TYPE II VARIANCE REQUEST

April 1, 2016

RE: Polaris Pointe – Phase I (8886 Lyra Drive)
CC# 17376
PID# 31843101017000

EXHIBIT C
DETAILS

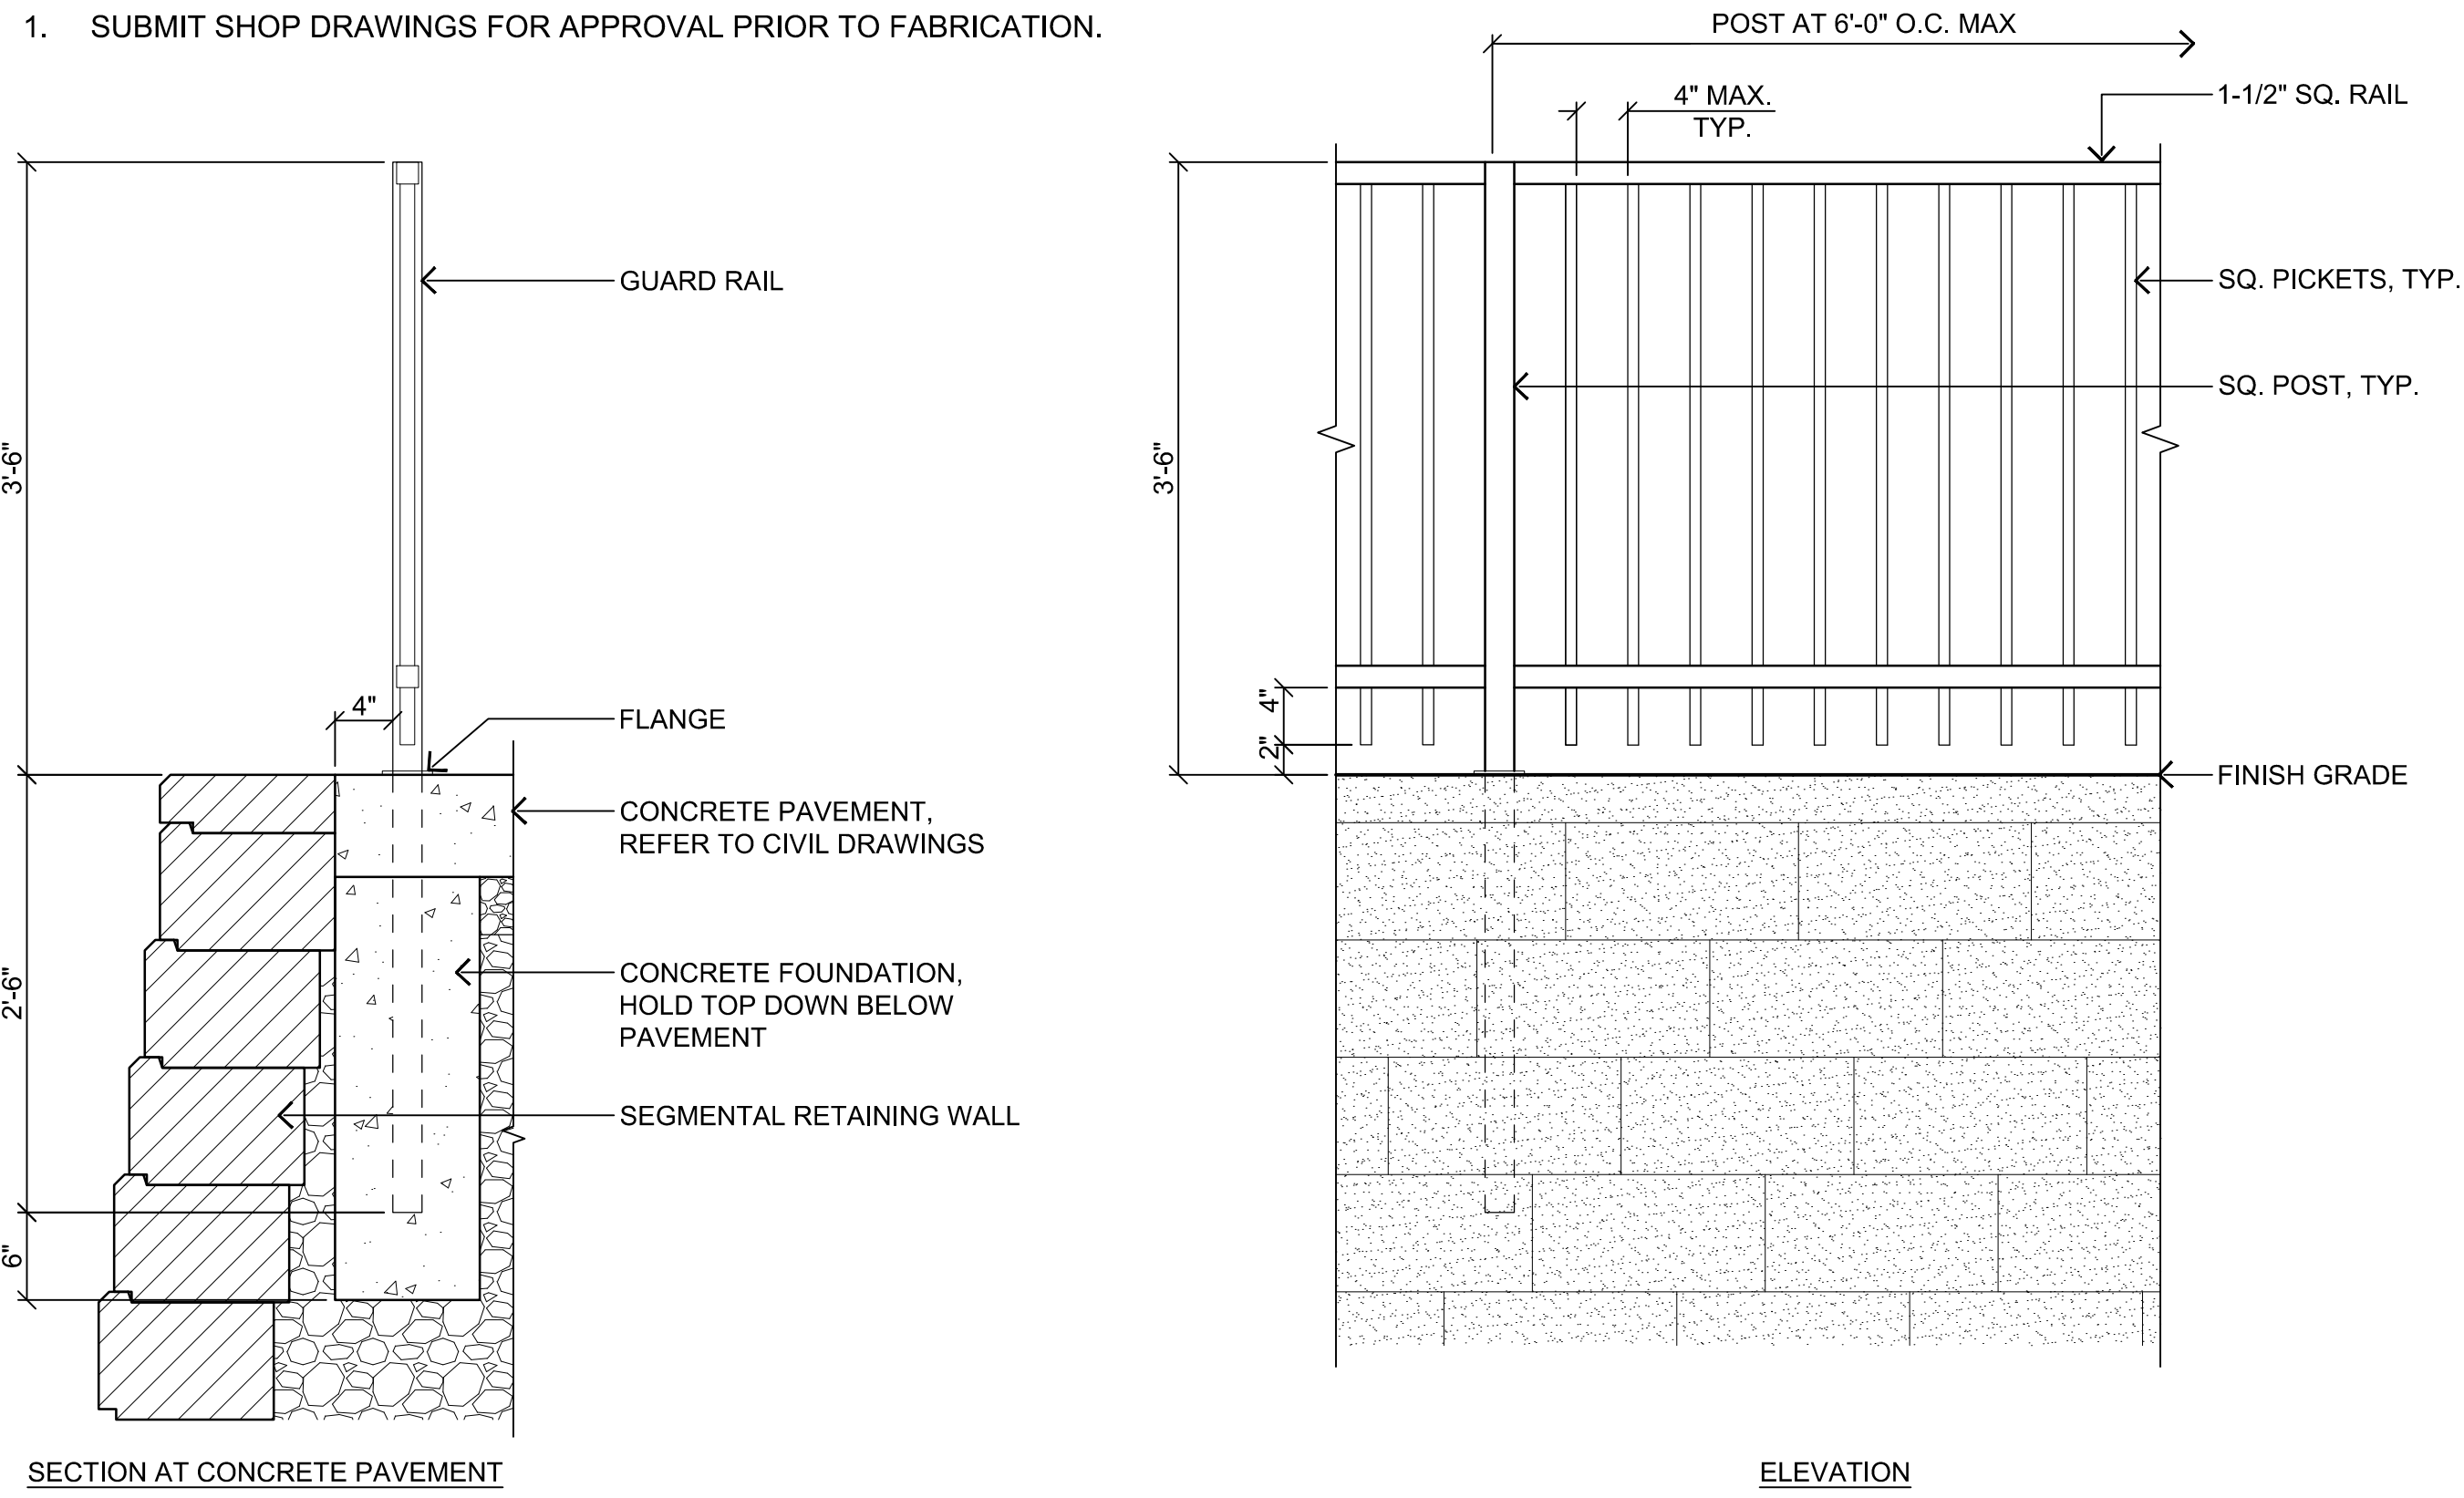
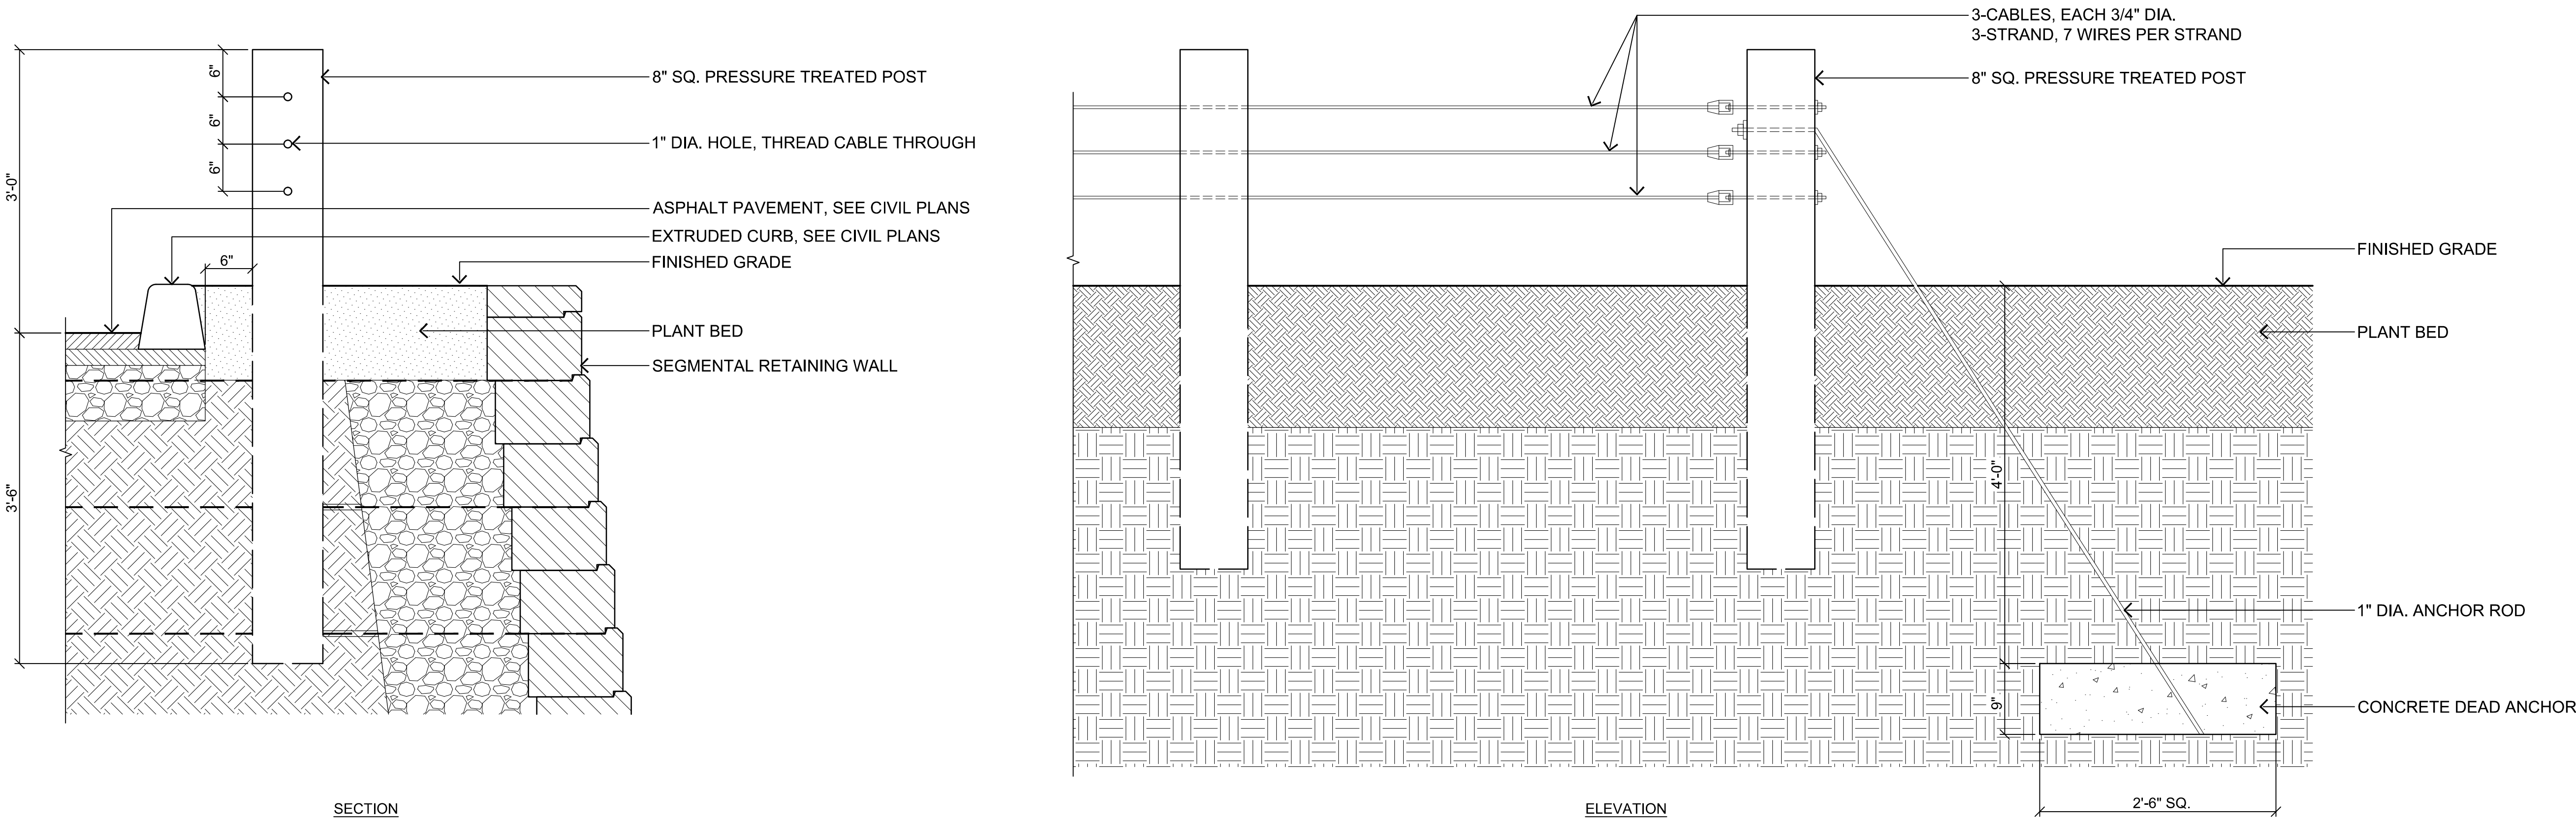
The developer is working closely with other departments at the City on T.I.F. agreements for public infrastructure to also make this project viable. The basin as proposed still will not fully meet the water quality and quantity volumes required. For this reason, the project is also proposing upstream, underground detention in the parking areas of the project. Since there is a proposed walk adjacent to the retaining wall on the south side of the basin, a 42" tall pedestrian guardrail is proposed on top for safety measures. The retaining wall on the west side of the basin includes curb, vehicular guardrail and landscaped area with trees and a continuous hedge for safety measures (See Exhibit C for a detail of the south and west cross sections). Note that the west side of the basin does not include sidewalk or pedestrian pathways along this edge so a taller guardrail has not been proposed on this side. In addition, previous projects in this area such as CC-16295 and CC-16925 have been approved with similar walls along ponds that also do not meet the slope or aquatic bench requirement due to the walls proposed.
